# PARTS & SERVICE NEWS

REF NO. AA04070

**SUBJECT:** REPAIR PROCEDURE FOR ENGINE IDLER SHAFT

**PURPOSE:** To introduce a modification procedure to repair the rear idler shaft

Fig. 1

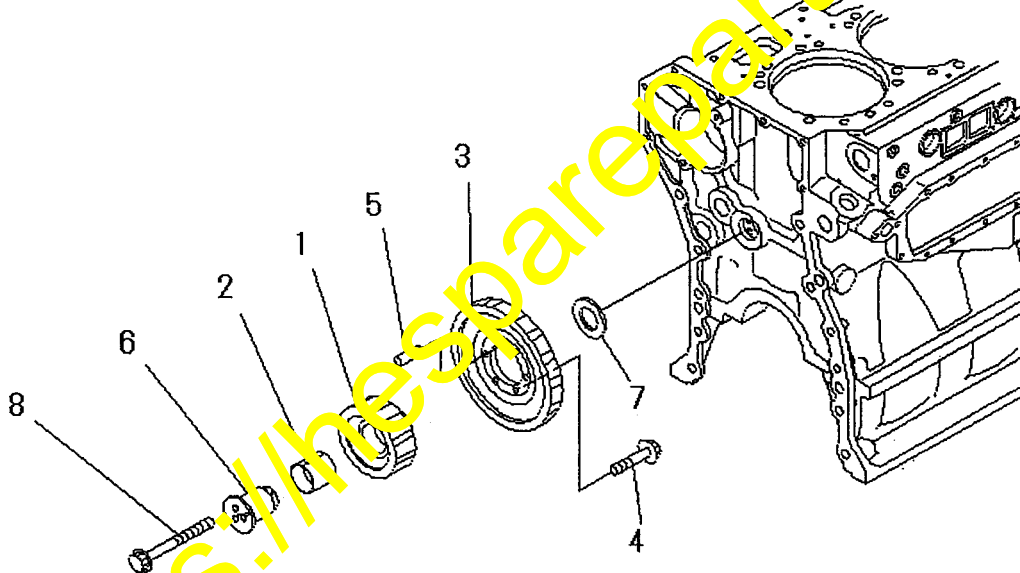
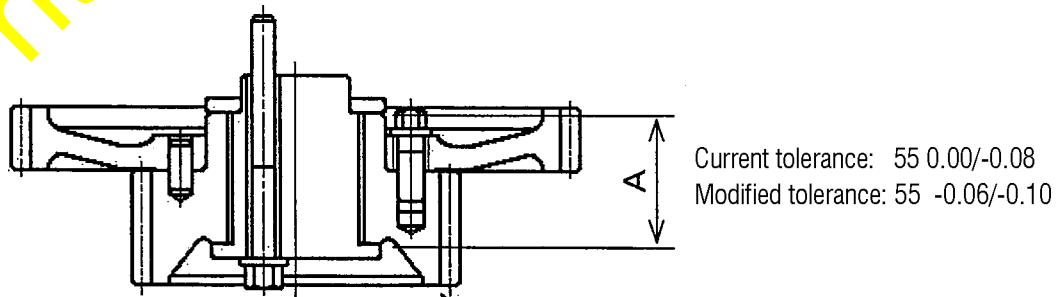
- 5) After the inspection and repair works, install the improved idler gear to restore the cylinder block.

Dimensions of the improved gear - To improve the lubricity, the tolerance of the dimension "A" has been modified as follows:

Current part: 6240-31-6110

Modified part: 6240-31-6111
